# City of Alexandria, Virginia

## MEMORANDUM

**SUBJECT:** REVISED PLANS for 700-710 NORTH WASHINGTON STREET  
BAR 2015-0026 and BAR 2015-0027

EXISTING BLDG - REVISED REAR PORCH

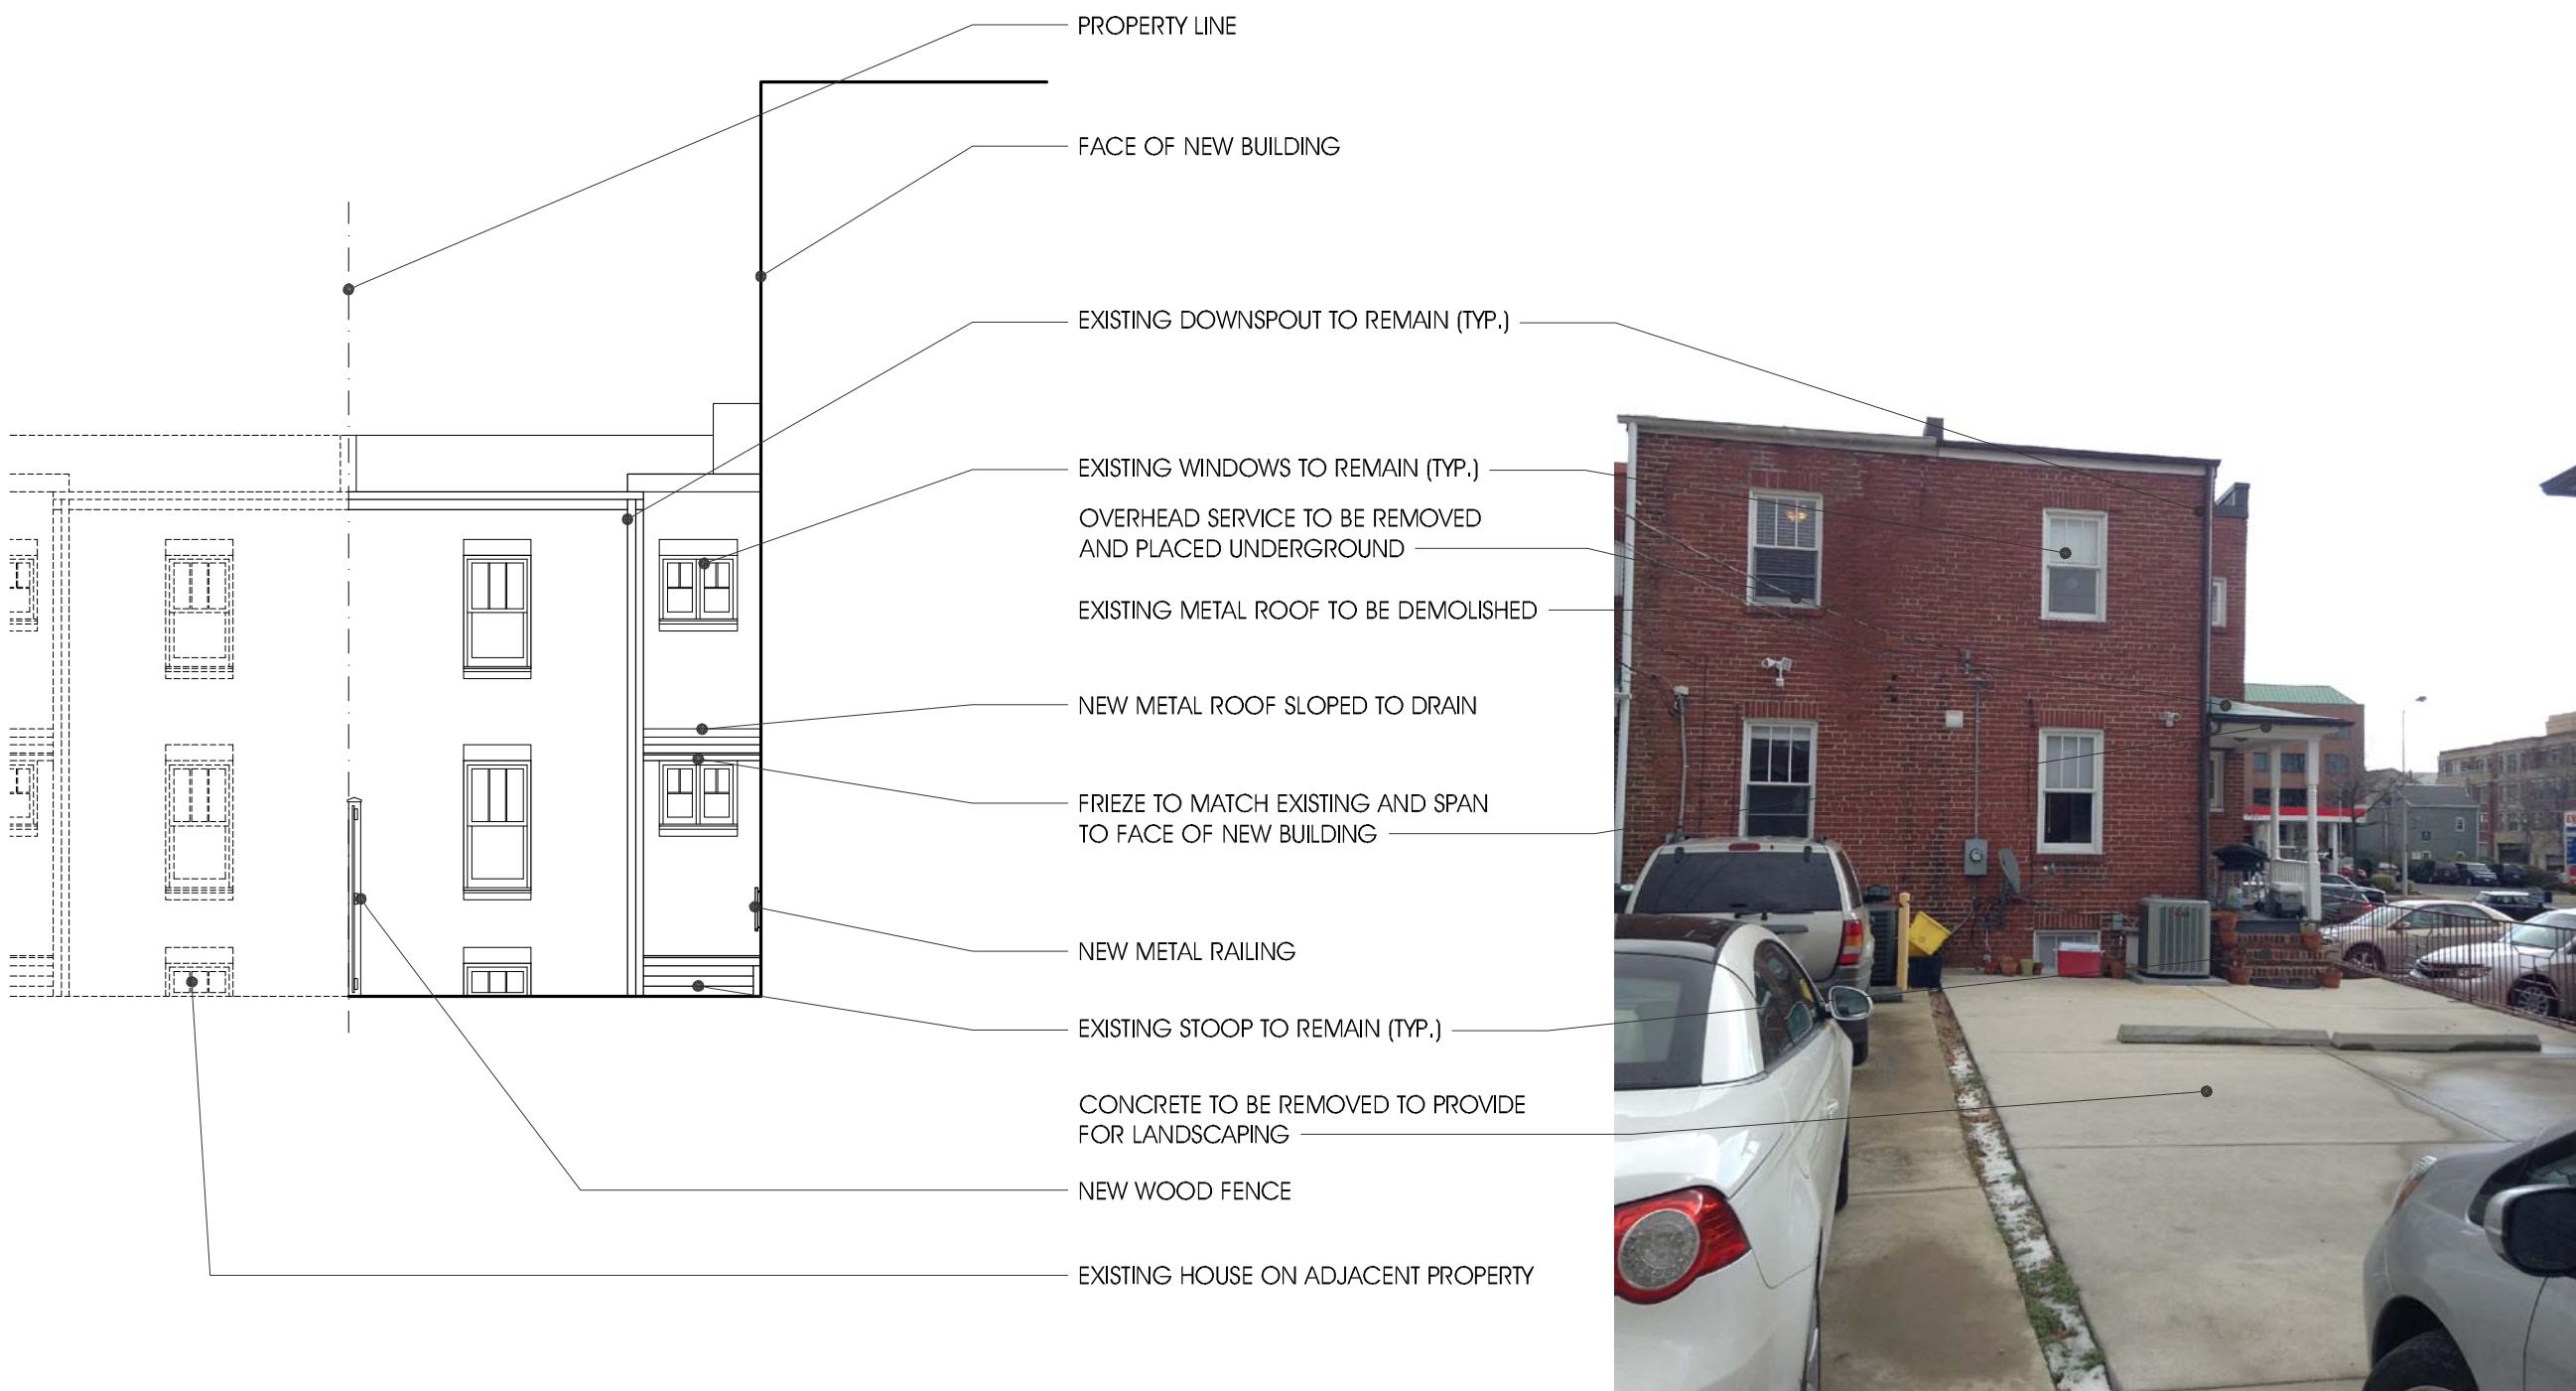
Condition 8. The applicant shall work with staff for the necessary alterations to reconfigure the roof of the one-story rear porch at 710 North Washington Street.

Response 8. The proposed changes to the porch roof at the rear of 710 N. Washington Street are included in the submission.

DORMER  
DETAILS

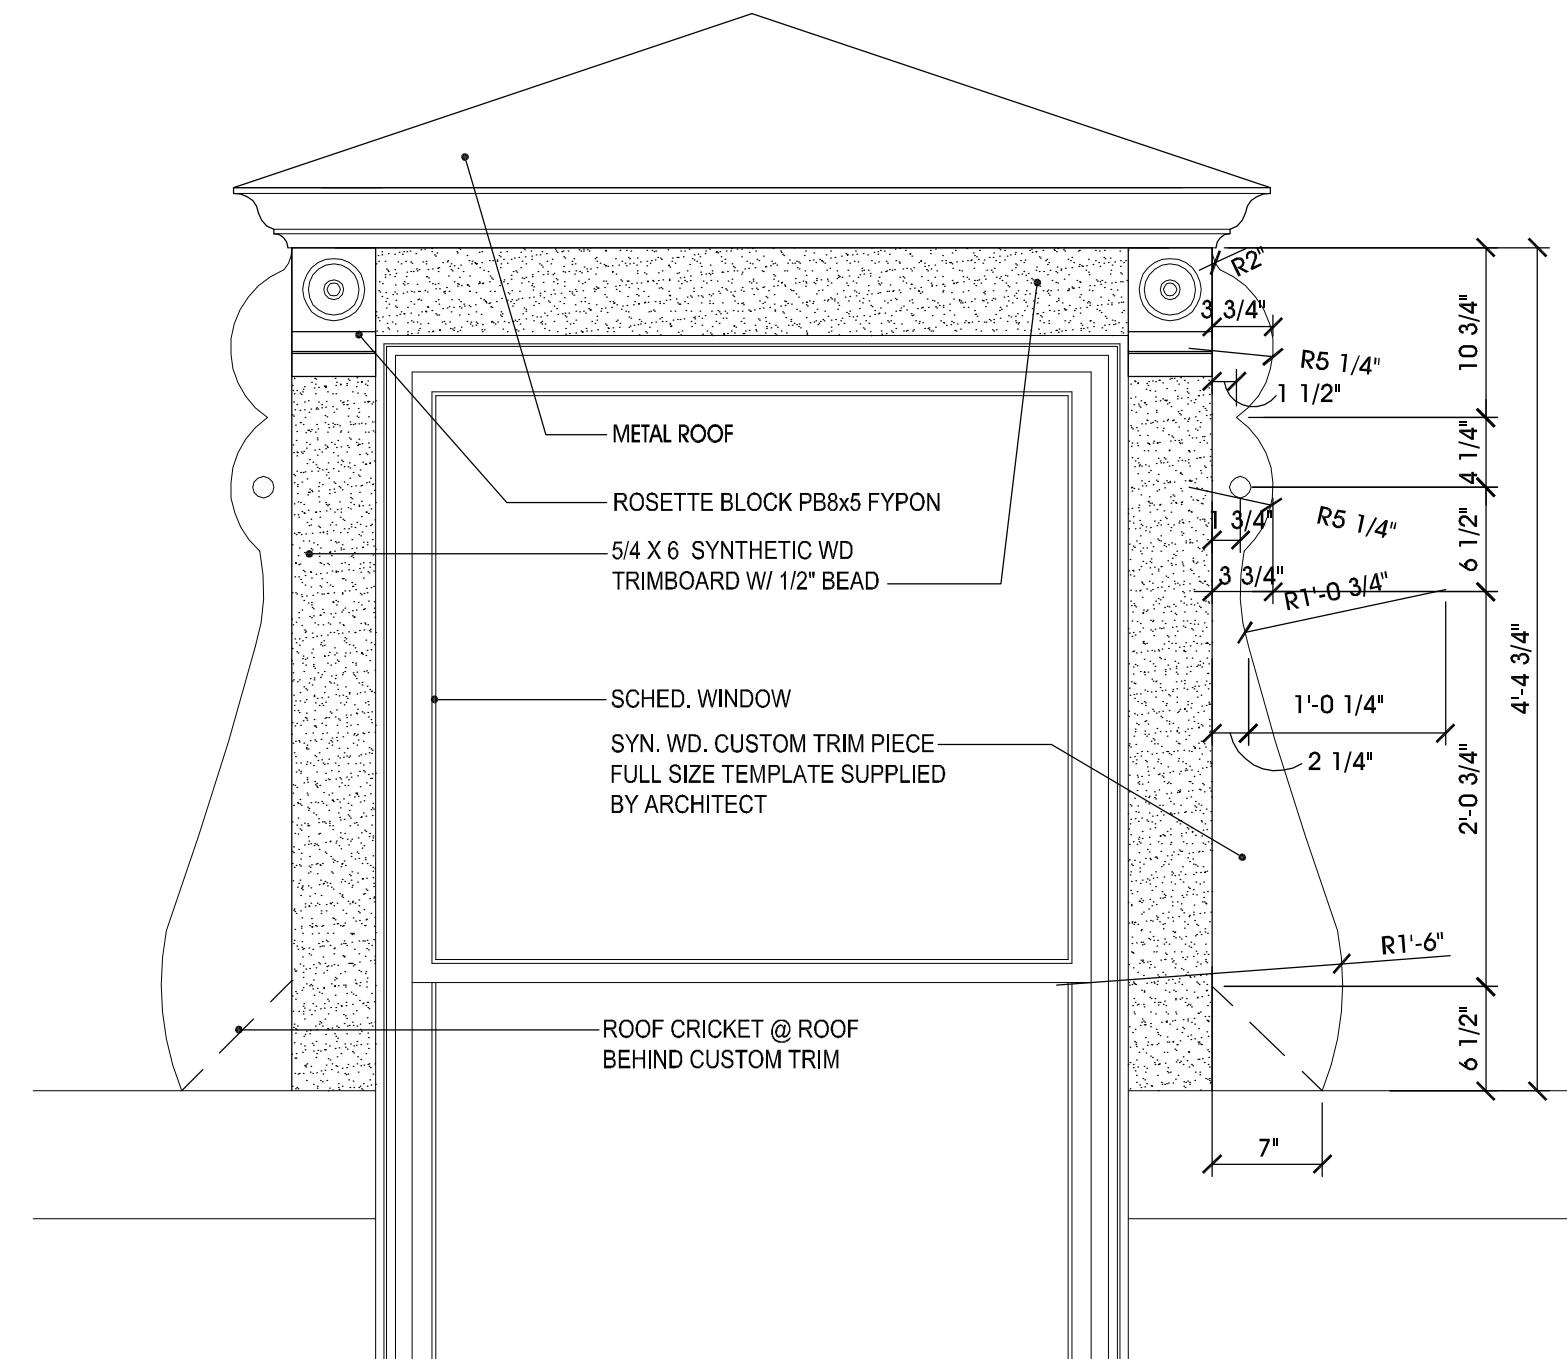
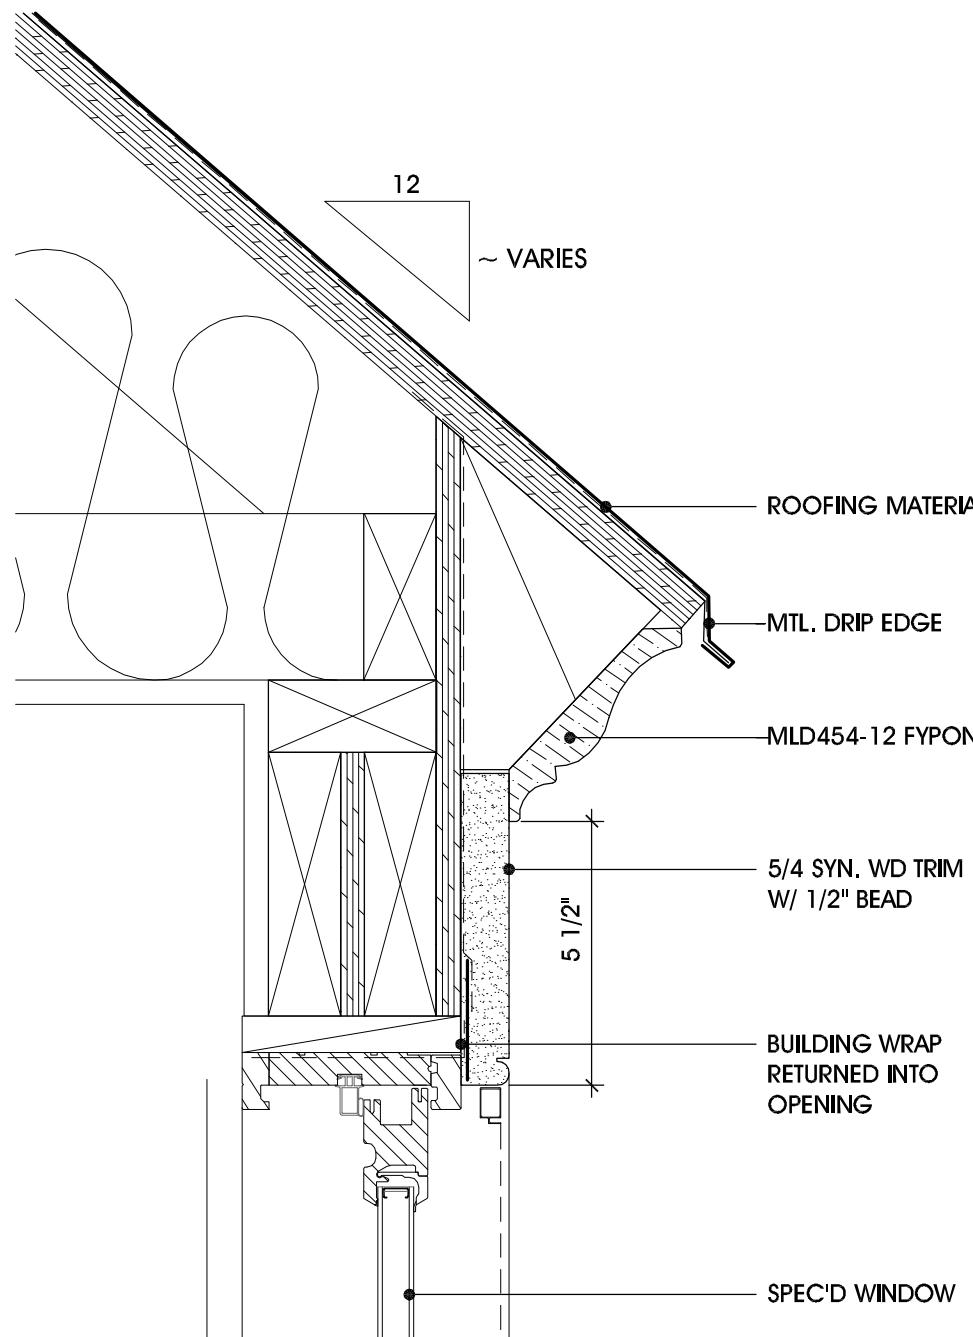
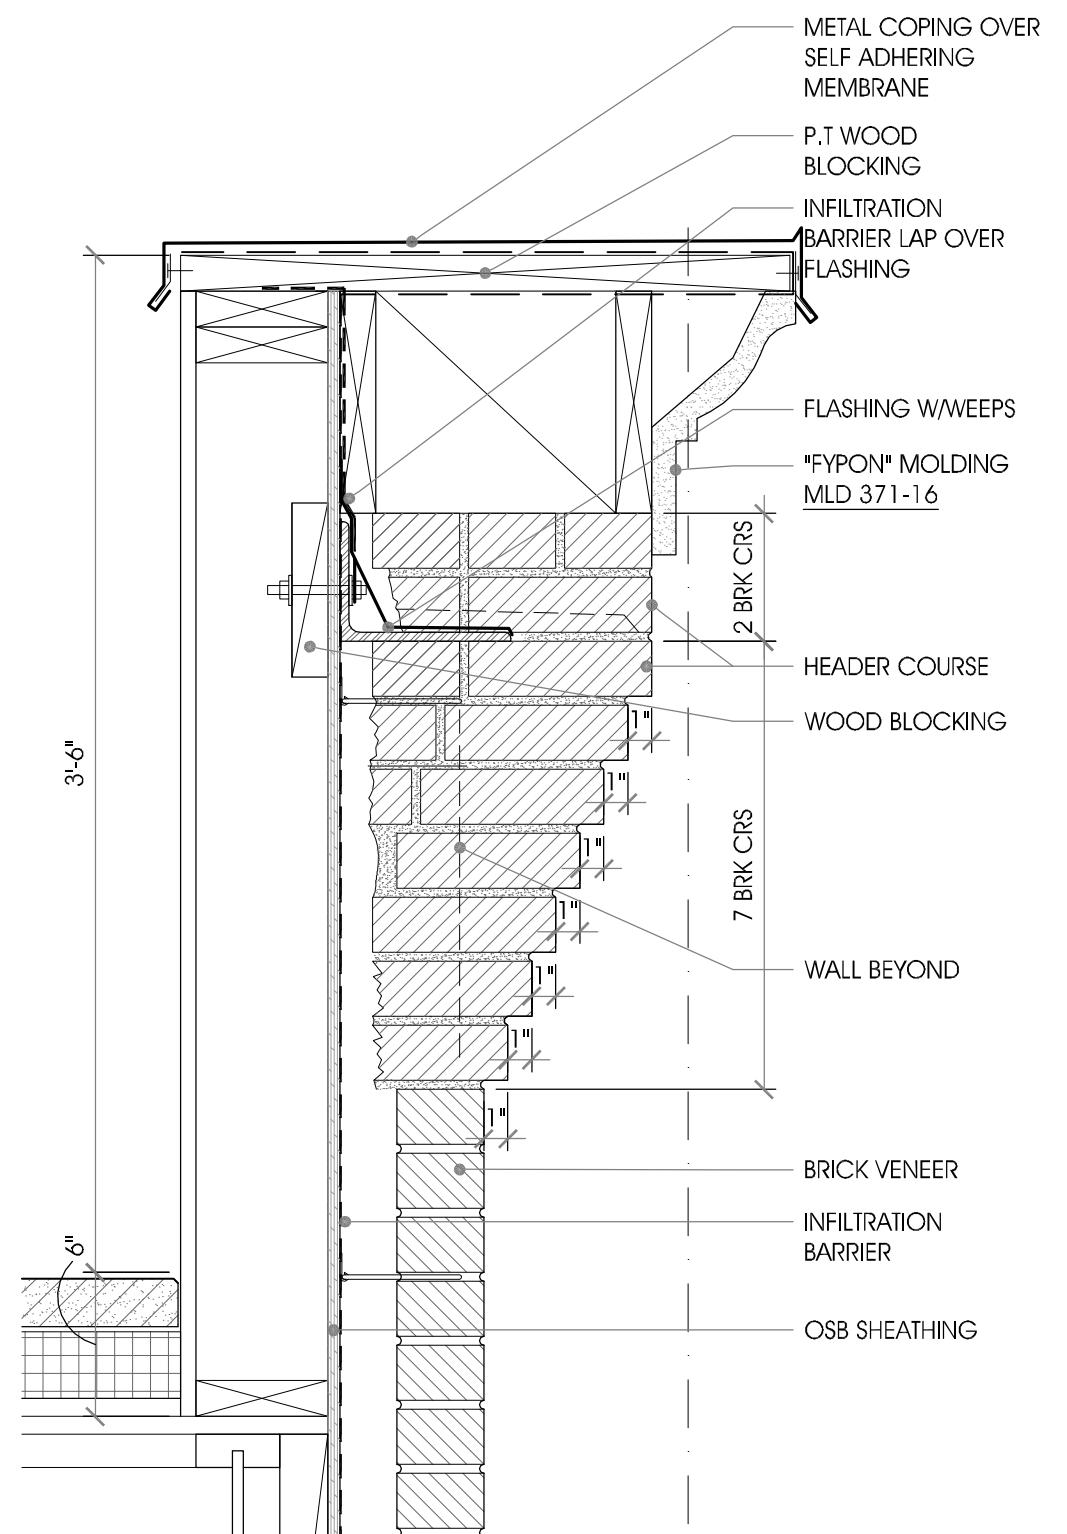
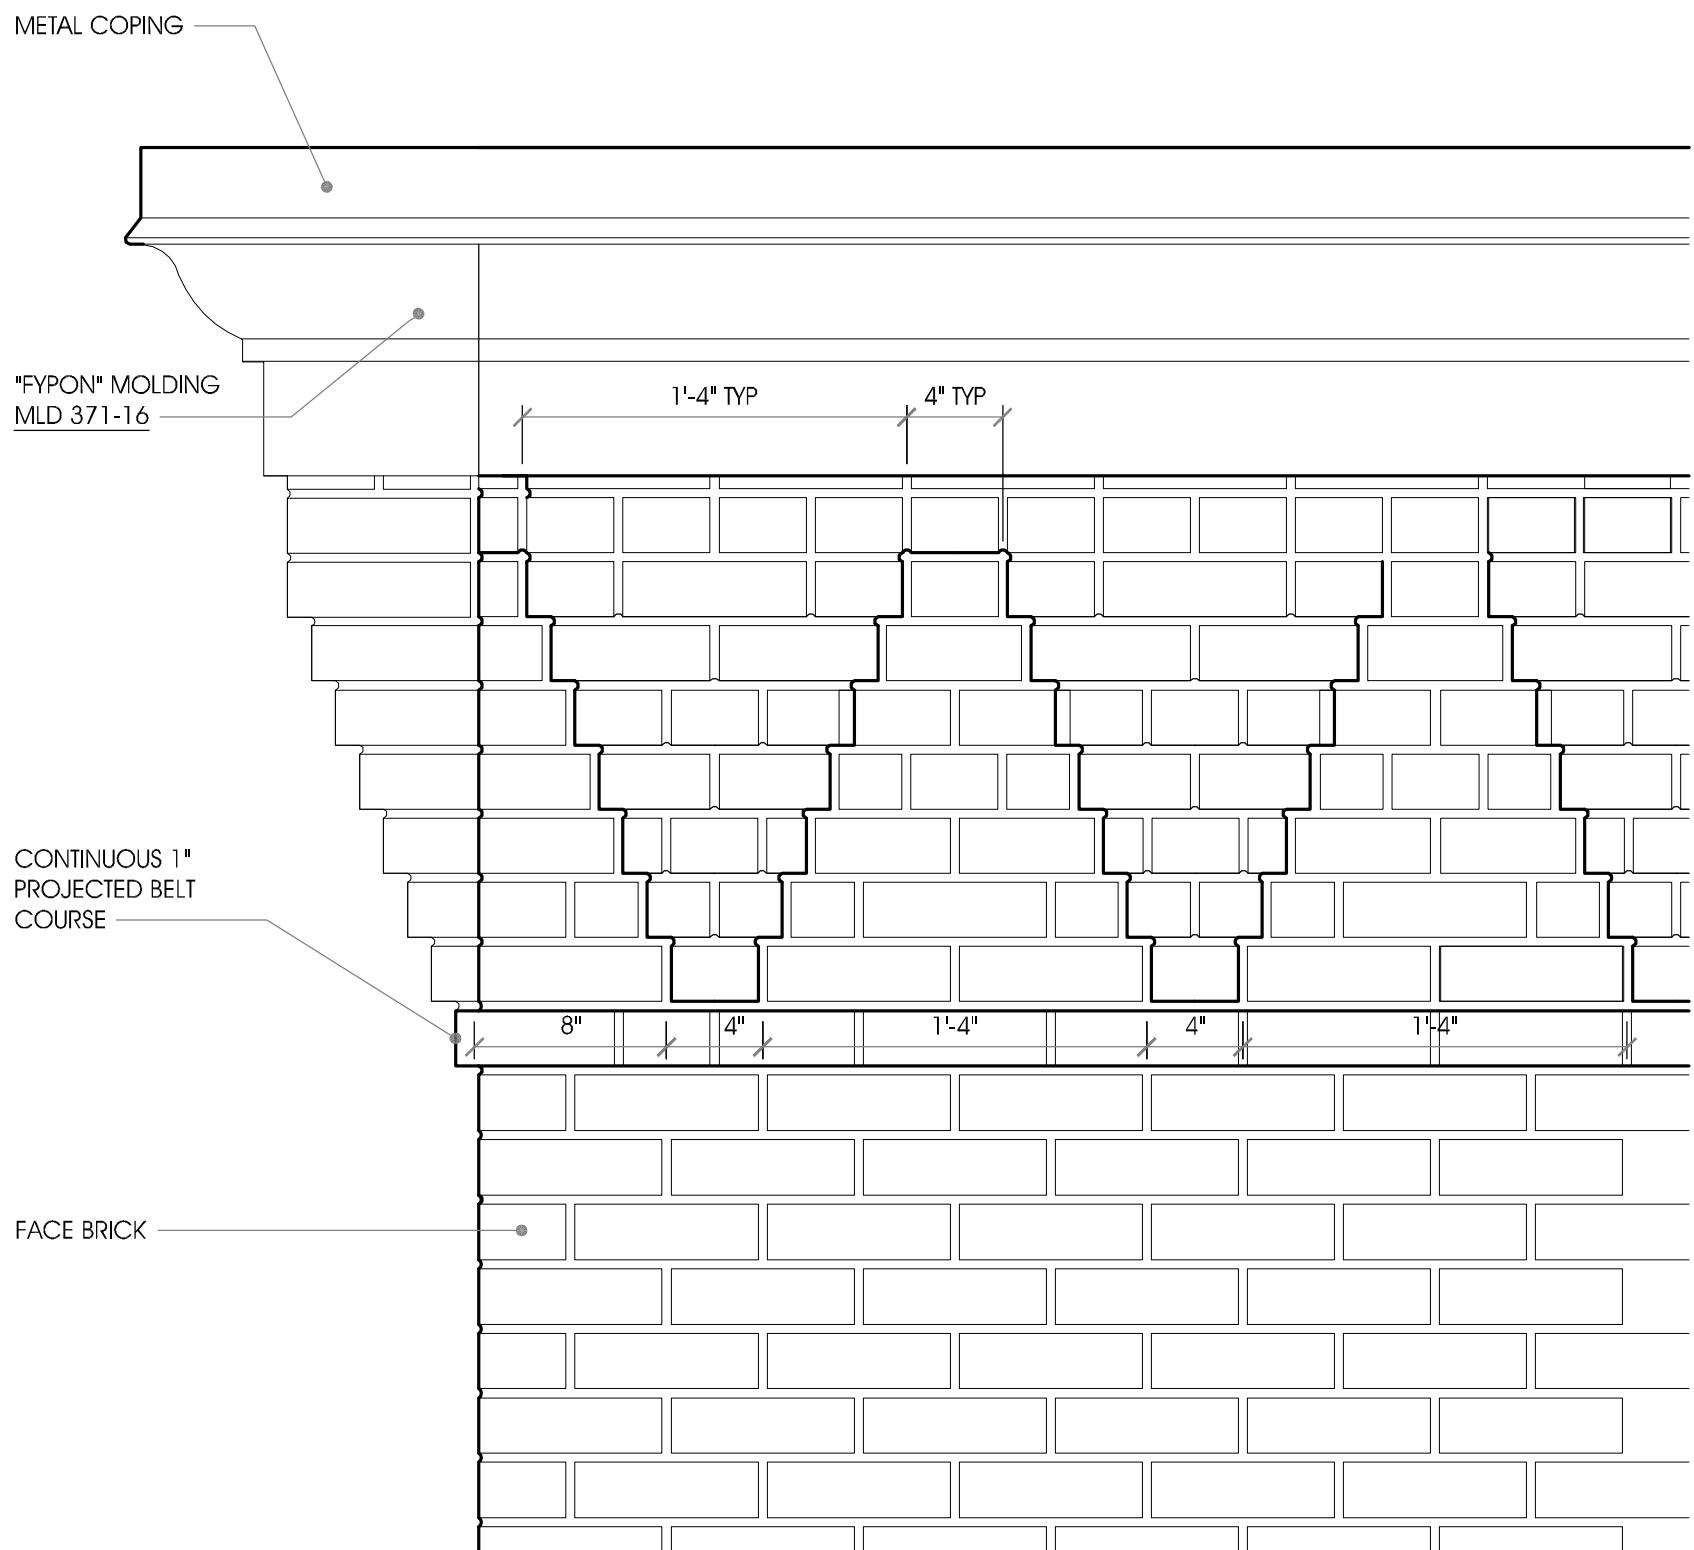
Condition 2. The applicant shall submit enlarged details and sections for elements such as corbelling, cornices, ornamental trim and the like for final approval by staff as part of the building permit review process.

Response 2. Cornice, corbelling and other details for decorative elements have been included in the submission.
